**Economic and Social Council**Distr.: General
14 January 2011Original: English
English and French only

Economic Commission for Europe**Inland Transport Committee****World Forum for Harmonization of Vehicle Regulations****Working Party on Lighting and Light-Signalling****Sixty-fifth session**

Collective amendments–Regulations Nos. 48 and 23**Proposal for the [01] series of amendments to Regulation
No. 23 (Reversing lights)****Submitted by the Chair of the task force on courtesy lamp of the
Working Party on Lighting and Light-Signalling***

Figure
Marking for single lamps

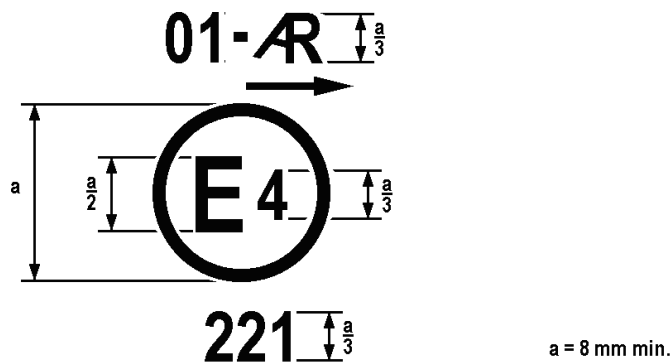
The device bearing the approval mark shown above is a reversing lamp approved in the Netherlands (E4) pursuant to Regulation No. 23 under approval number 221. The approval number indicates that the approval was granted in accordance with the requirements of Regulation No. 23 ~~in its original form or as amended by Supplements 1 and/or 2, as the case may be~~ **by the [01] series of amendments**. The arrow indicates the side on which the required photometric specifications are met up to an angle of 45° H.

Figure 5
Marking for an manoeuvring lamps

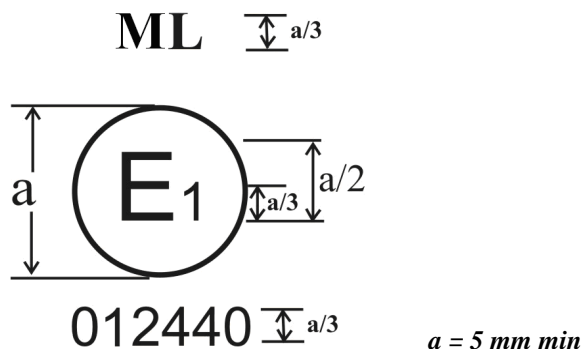
The device bearing the approval mark shown above is a manoeuvring lamp approved in Germany (E1) pursuant to Regulation No. 23 under approval number 2440.

The approval number indicates that the approval was granted in accordance with the requirements of Regulation No. 23 in its original form as amended by the [01] series of amendments.
